BCA ASSESSMENT REPORT

**Yiribana Logistics Estate, Kemps Creek
Warehouse 1 & 3 (Stage 1)**

**Prepared For:
The GPT Group**

Revision 4

Figure 1 – Warehouse 1 Perimeter Vehicular Access per BCA C2.4.

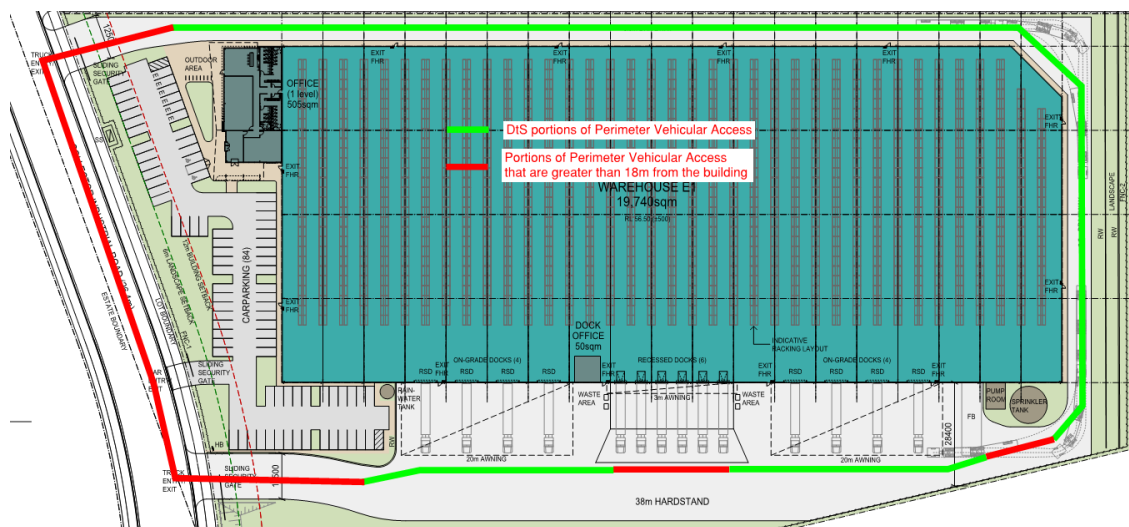
Comments: The proposed Warehouse buildings do not comply with the provisions of C2.4 and thus the following non-compliance issues are required to be addressed as a Performance Solution by the Fire Engineer to demonstrate compliance with Performance Requirement CP9:

- + Perimeter Vehicular Access is greater than 18m from the external walls along the western side of the building, along the southern side of the warehouse at the recessed docks and in the south-eastern corner near the sprinkler tank & pump room – refer below mark-up:

Warehouse 3

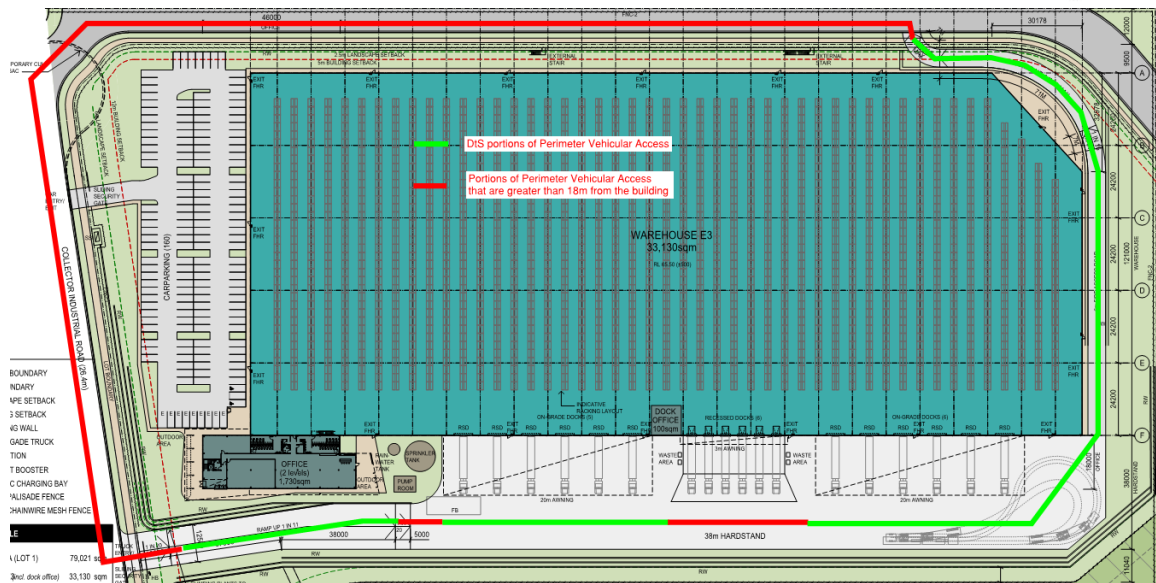
- + Perimeter Vehicular Access is greater than 18m from the external walls along the northern and western side of the building, along the southern side of the warehouse at the recessed docks and near the sprinkler tank & pump room – refer below mark-up. Additionally, consideration will need to be given to when the future road to the northern side of the warehouse will be completed, and any potential impacts on the below assessment if the road is not completed before an Occupation Certificate is required for the warehouse. Any temporary arrangements will need to be considered in the Performance Solution.

Note 1: Any proposed sliding gates are to achieve no less than 6m unobstructed width or the reduced width will need to be included in the above Performance Solution.
